ITEM SUPPLEMENTARY 20
MANAGER'S REPORT NO. 48
COUNCIL MEETING 1984 07 23

RE: REZONING REFERENCE #19/84
S ½ OF LOT 6, D.L. 82, PLAN 11987
4885 ROYAL OAK AVENUE
(ITEM 18 OF ITEM 8, REPORT NO. 21, 1984 MARCH 19)

SUBJECT: REZONING REFERENCE #19/84
S 1/2 OF LOT 6, D.L. 82, PLAN 11987

ADDRESS: 4885 ROYAL OAK AVENUE

SKETCH #1 164

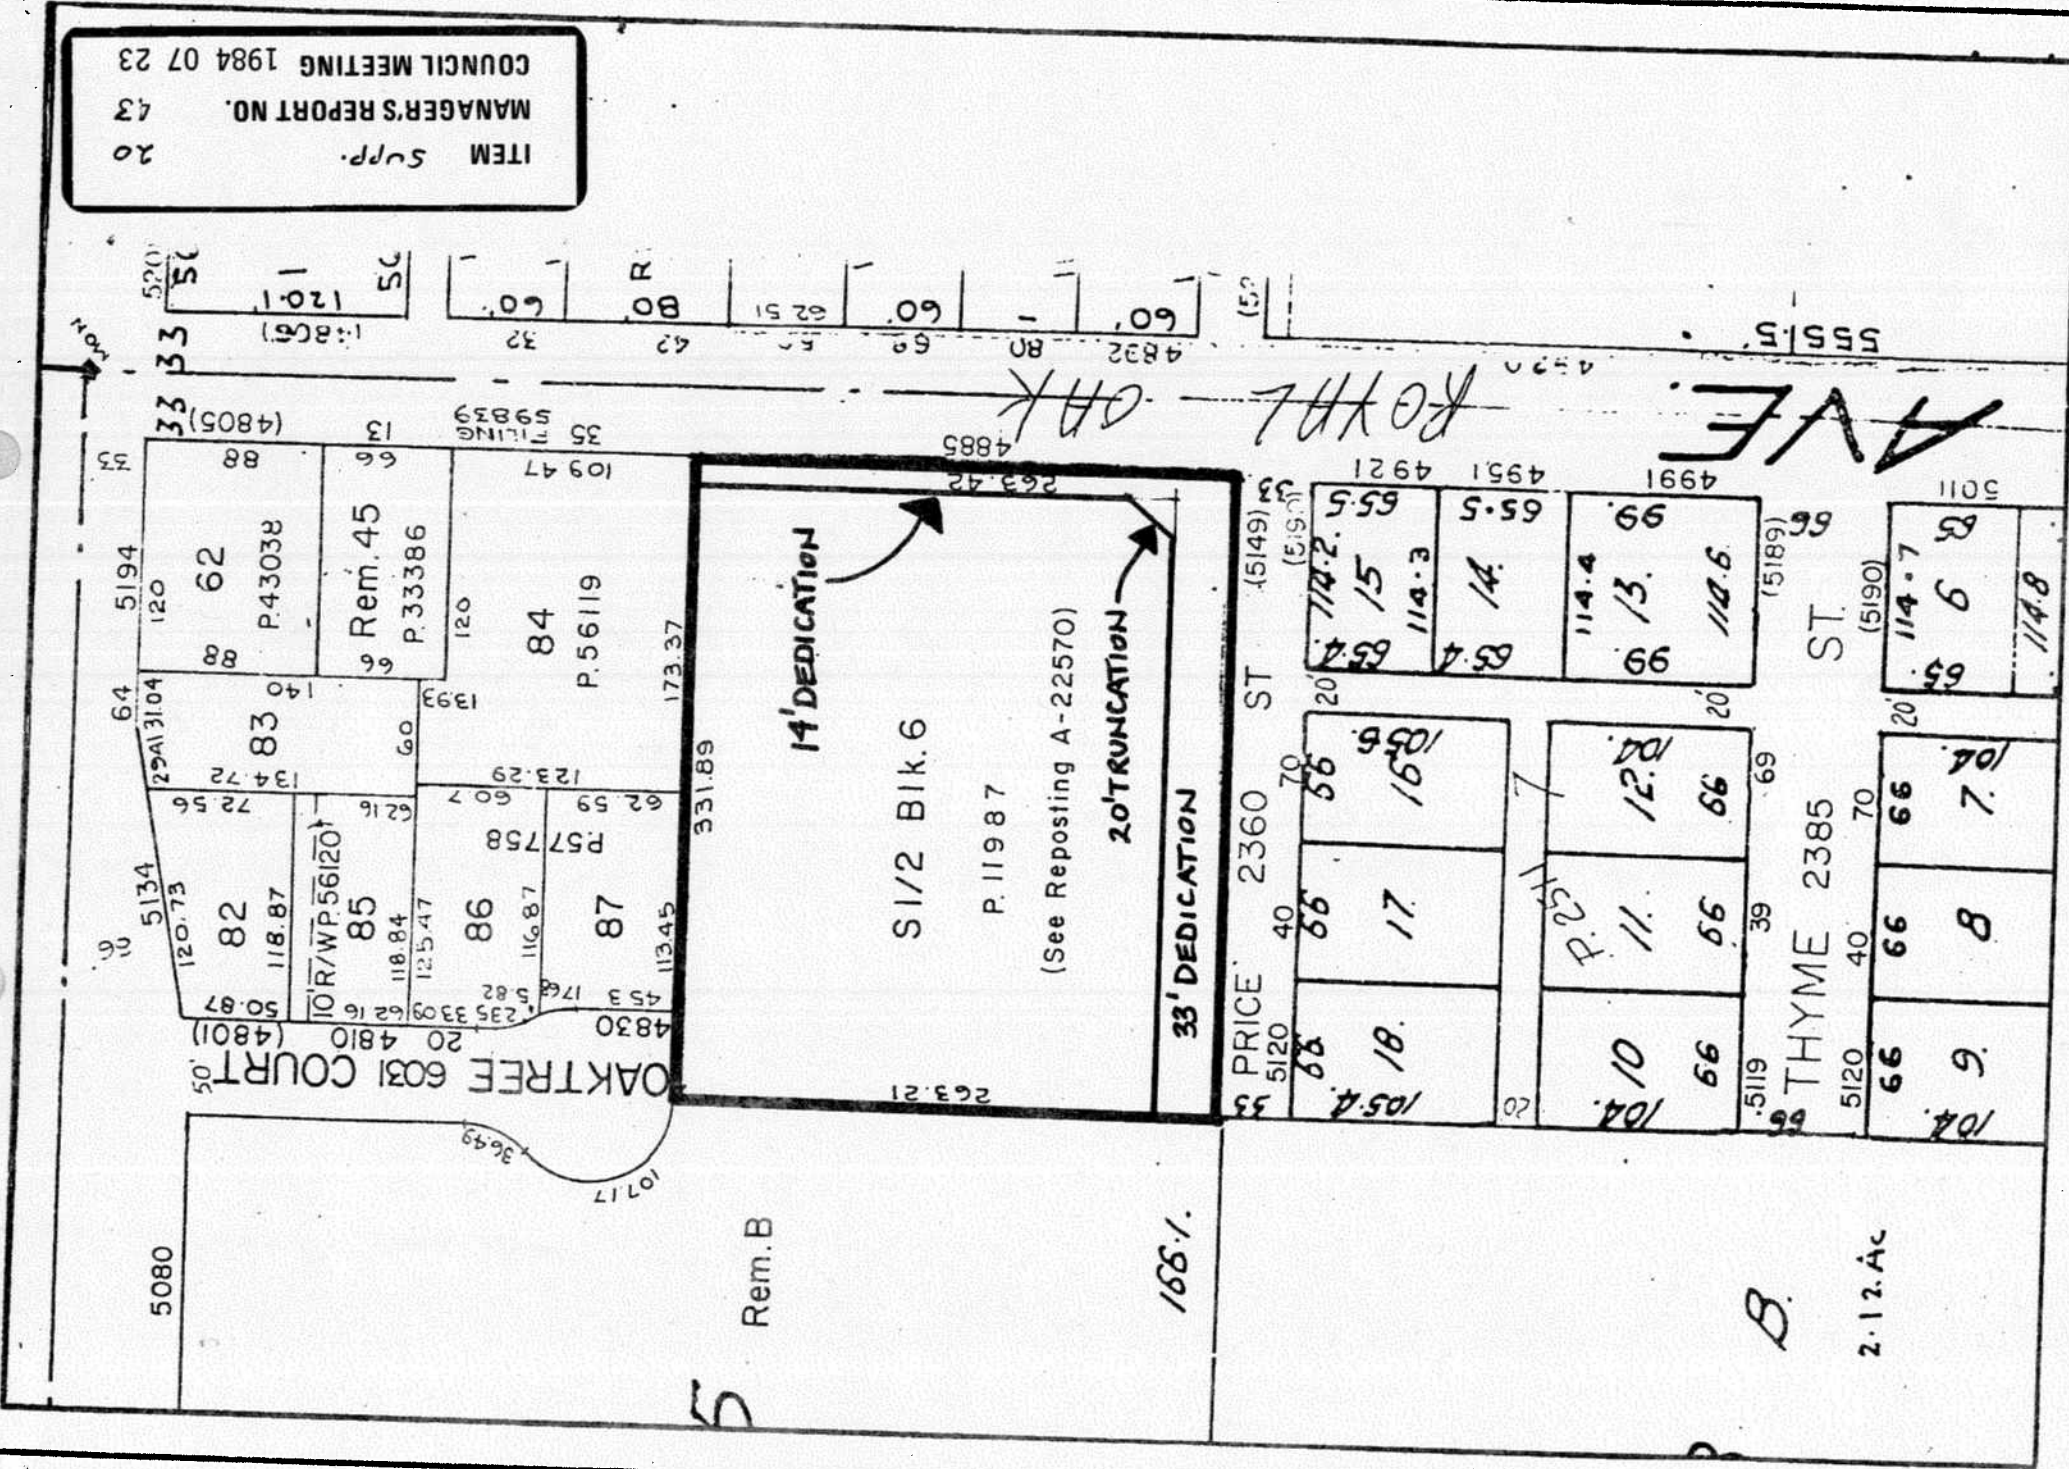
2.4 In view of the foregoing information, this Department can recommend a minor realignment of the proposed Moscrop/Gilpin Diversion to the south. However, the realignment will still require the dedication of the southerly 33 ft. (a normal requirement permitted by the Municipal Act) and the easterly 14 ft. of the subject site with a 20 ft. truncation (as outlined on the attached sketch) to appropriately accommodate the future road developments. The 33 ft. dedication will correspond to the existing 33 ft. Price Street road alignment which was required of the residential subdivision to the east of the subject site across Royal Oak Avenue.

2.6 It is therefore recommended that Council amend the original prerequisite condition of rezoning and require only those dedications shown on sketch 1 and outlined in this report.

1. THAT Council amend the original prerequisite condition of rezoning and require only those dedications shown on Sketch 1 and outlined in this report.
